I write to formally object to the proposed installation of 8 metre high floodlighting columns at the neighbouring property, on the grounds of the following:-

I note from the supplied diagram from the lighting assessment 250285-LTBL-REP-001 Figure 2 – Residential receptors that our property is not even on the diagram. Therefore, I have added below for clarity.

Figure 7. Illuminance view

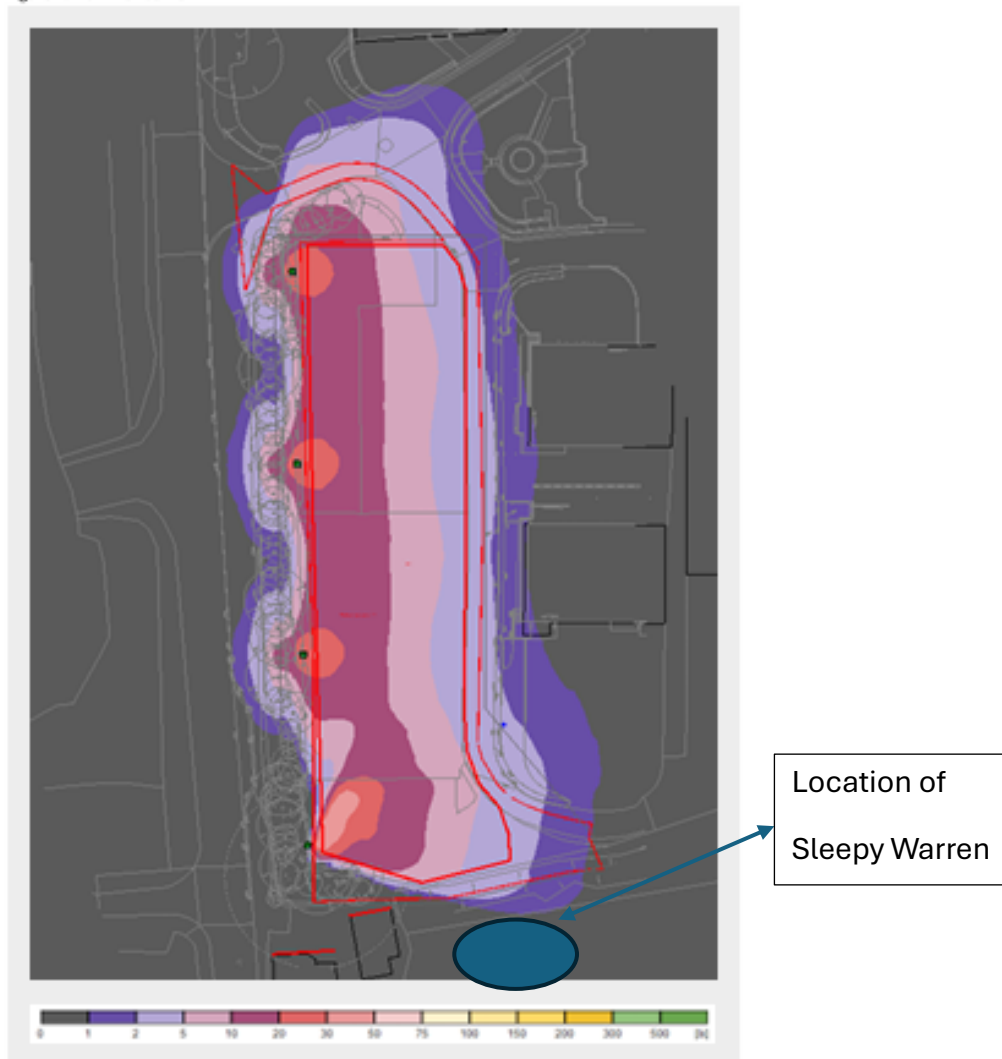
Therefore, we will take the full brunt of any lighting of this scale and in particular the column closest to our boundary as this is facing directly towards us and not at the same trajectory and the other proposed lighting columns. The lighting lux drawing indicates this even with the external glare shield on type B column Figure 7 . illuminance view clearly shows the extent of such glare onto our property.
